Model: Stinger-C1 DF (DF68)	Date: 15-Jan-00	No.: MA859001a
-----------------------------	-----------------	----------------

Modified Article: Parts Catalog Correction		Prepared by: K. Miura	
From: Technical Services Dept., GTS Division			
Reason for Modification:	<input checked="" type="checkbox"/> Parts catalog correction	<input type="checkbox"/> Vendor change	<input type="checkbox"/> To meet standards ( )
	<input type="checkbox"/> To facilitate assembly	<input type="checkbox"/> To improve reliability	
	<input type="checkbox"/> Part standardization	<input type="checkbox"/> Other

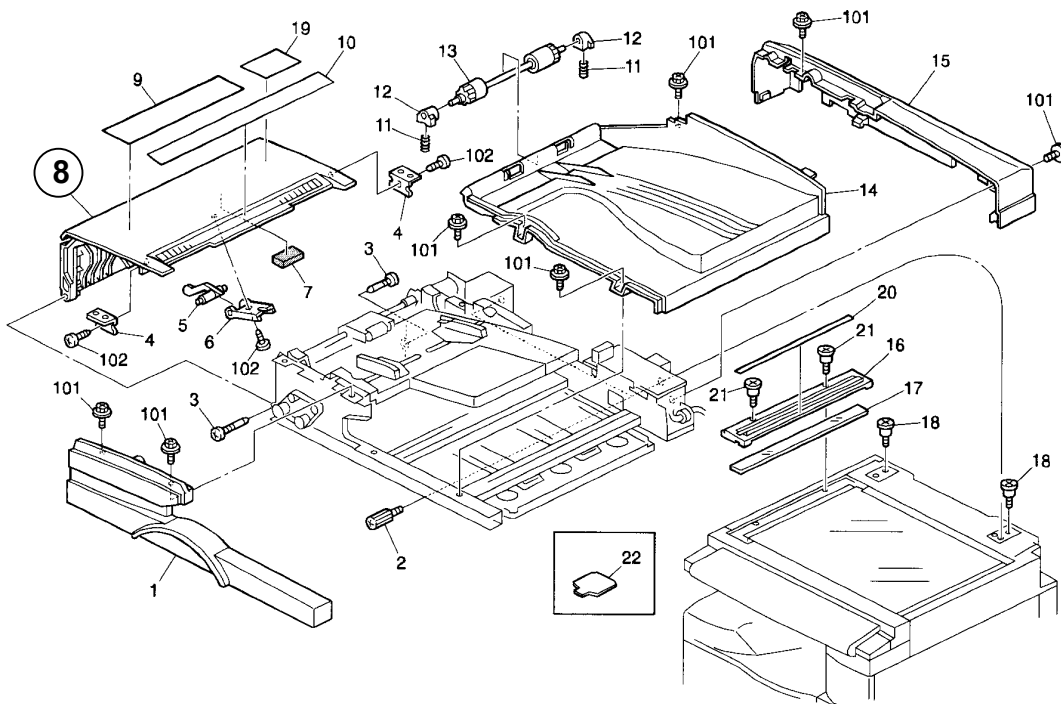
When the document approaches the transport rollers, it can sometimes contact the pullout lever due to warping in the left cover. The left cover has been changed to reduce the possibility of this happening.

Old part number	New part number	Description	Q'ty	Int	Page	Index	Note
A8594841	A8594842	Left Cover	1	X/O	3	8

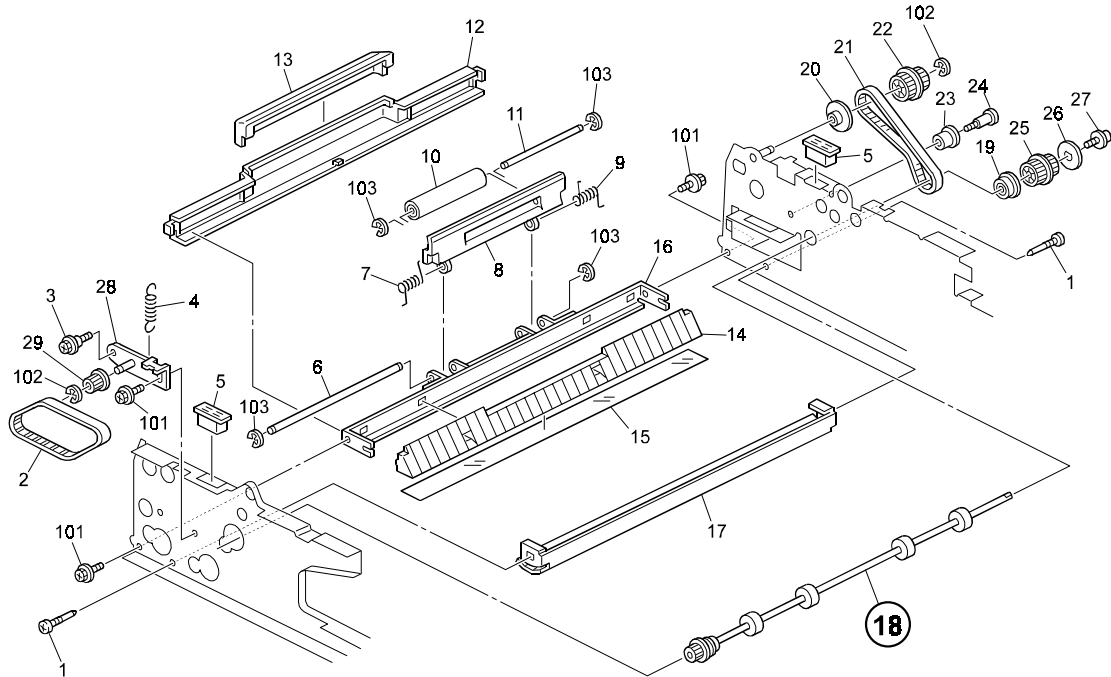
To minimize vibration of originals during paper feed, the following has been changed:

Old part number	New part number	Description	Q'ty	Int	Page	Index	Note
A8593130	B3863130	Exit Roller - Drive	1	O/O	9	18

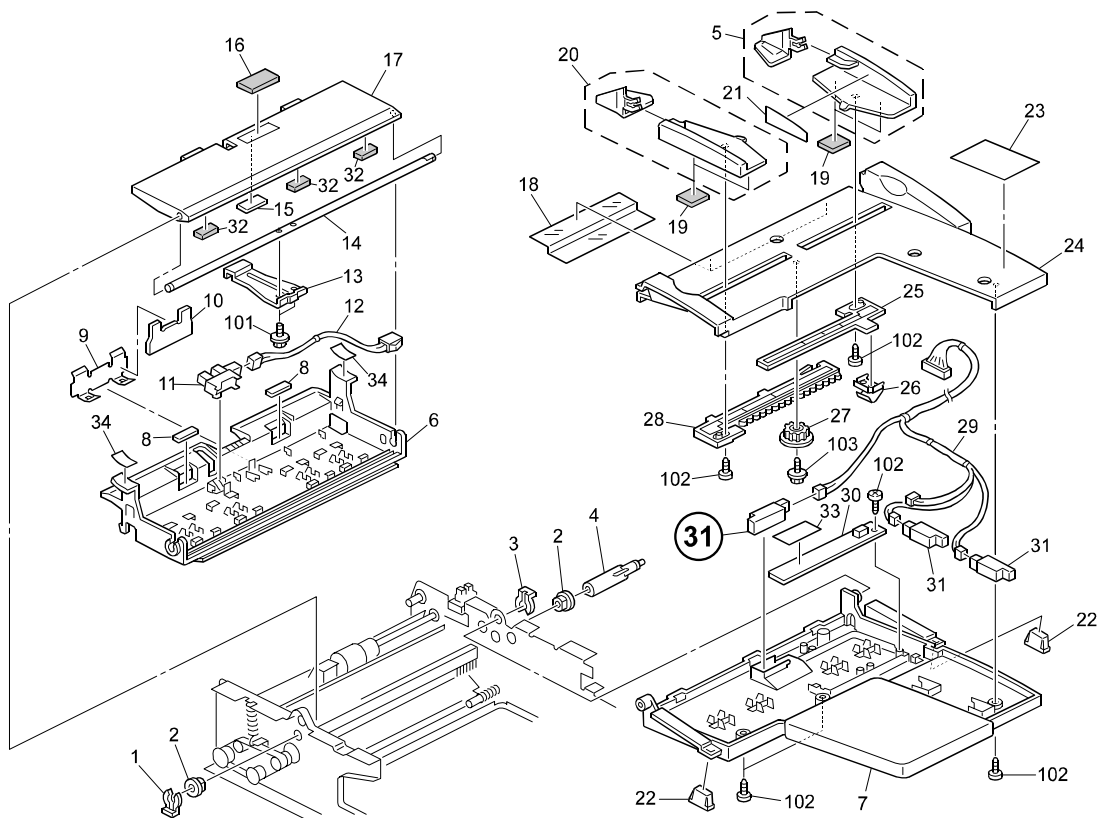
Please correct your Parts Catalog as follows:

Part number	Description	Old Q'ty	New Q'ty	Page	Index	Note
AW010087	Photo Sensor - A'ssy	2	3	5	31

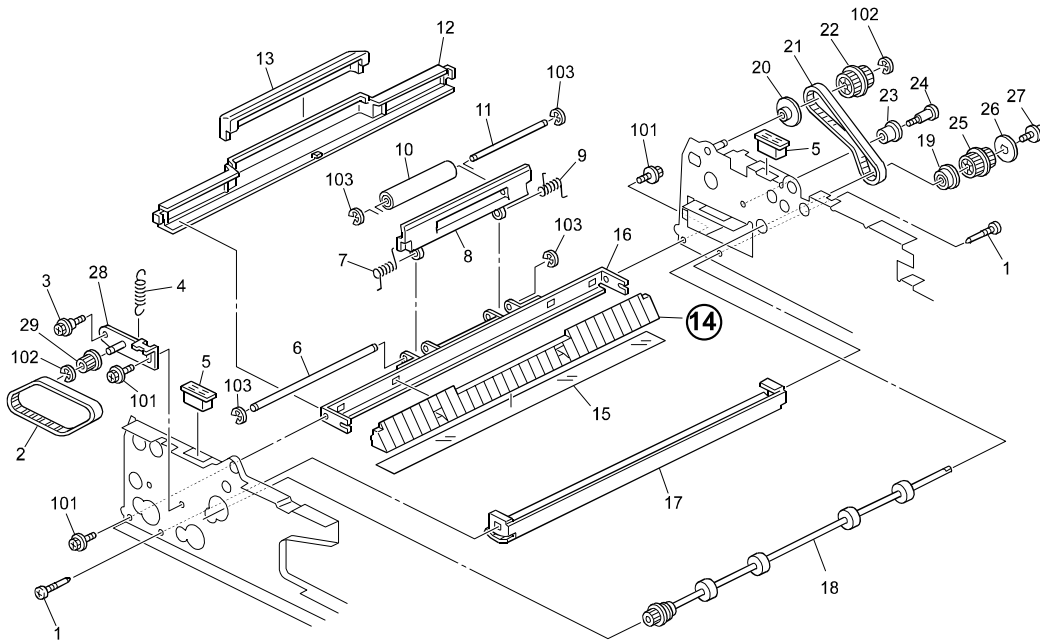
To ensure the junctions of the Lower Left Guide stay properly in position when the ADF is installed, the guide has been changed.

Old part number	New part number	Description	Q'ty	Int	Page	Index	Note
A8591721	A8591723	Left Lower Guide	1	X/O	9	14

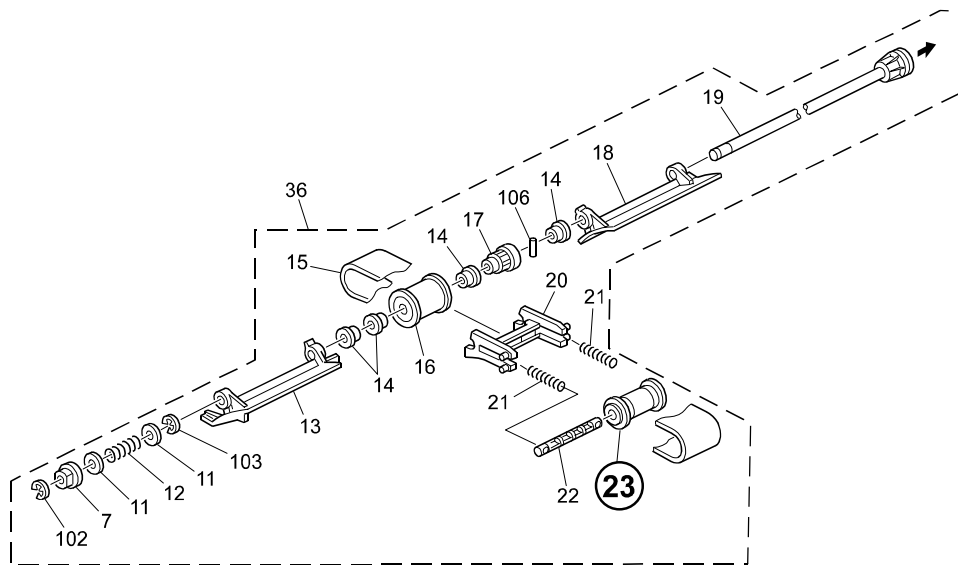
The following has been changed due to parts standardization with other models.

Old part number	New part number	Description	Q'ty	Int	Page	Index	Note
A8592113	B3872113	Drive Roller - Paper Feed Belt	1		7	23	
		Roller - Paper Feed Belt	1	O/O	7	23

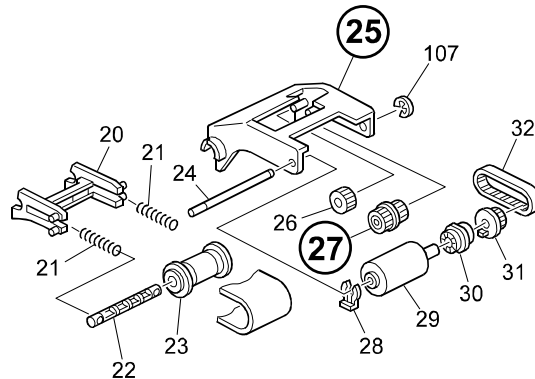
The following have been changed to further ensure that the shaft of the Pickup Holder for the Pulley is not damaged.

Old part number	New part number	Description	Q'ty	Int	Page	Index	Note
A8592151	G4123821	Holder - Pick Up	1	X/X	7	25	
A8592168	G4123831	Pulley - 22Z	1	X/X	7	27

**Note:** These parts must be replaced together as a set.
